# Work Order ID 73078

Item Name: Basket Hoop

DRAWING NO. D3166	TITLE BASKET HOOP	REVA1	<b>DART AEROSPACE LTD ENGINEERING ORDER</b>		D.E.O. NO. D3166-A-2	SHEET NO. 1 OF 1	SCALE NTS
DRAWN AJS	CHECKED <i>[Signature]</i>	MFG. APPR. <i>[Signature]</i>	APPROVED <i>[Signature]</i>		DE APPR. <i>[Signature]</i>		
DATE 08.12.11	DATE 08.12.15	DATE 08/12/15	DATE 08/12/16		DATE 08.12.16

DESIGN #	DRAWN BY CP	DART AEROSPACE LTD HAWKESBURY, ONTARIO, CANADA	
CHECKED #	APPROVED #	DRAWING NO. D3166	REV. A SHEET 1 OF 1
DATE 02.07.10		TITLE BASKET HOOP	SCALE NTS
A	02.07.10	NEW ISSUE	
A1	04.04.08	38+/-1 WAS 36.0

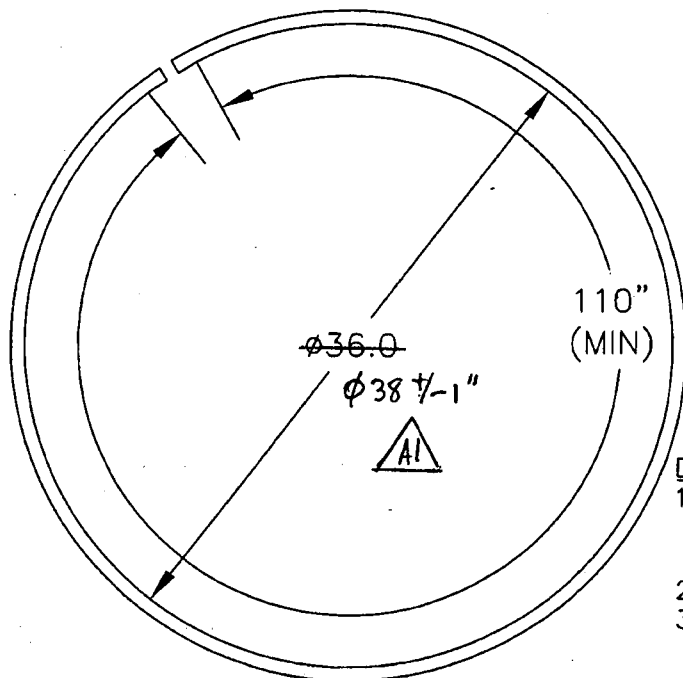
1) MODIFY MATERIAL NOTE FOR D3166-1 AS SHOWN:

2) MODIFY MATERIAL NOTE FOR D3166-3 AS SHOWN:

REASON: SEE PAR 08-005

**IS:**

1) MATERIAL: AISI 304/316 SS, 3/4 X 3/4 X 0.065 WALL SQUARE TUBING,  
60.00" LONG  
REF. DART SPEC M304TS0.750W.065

**IS:**

1) MATERIAL: AISI 304/316 SS, 3/4 X 3/4 X 0.065 WALL SQUARE TUBING,  
120.00" LONG  
REF. DART SPEC M304TS0.750W.065
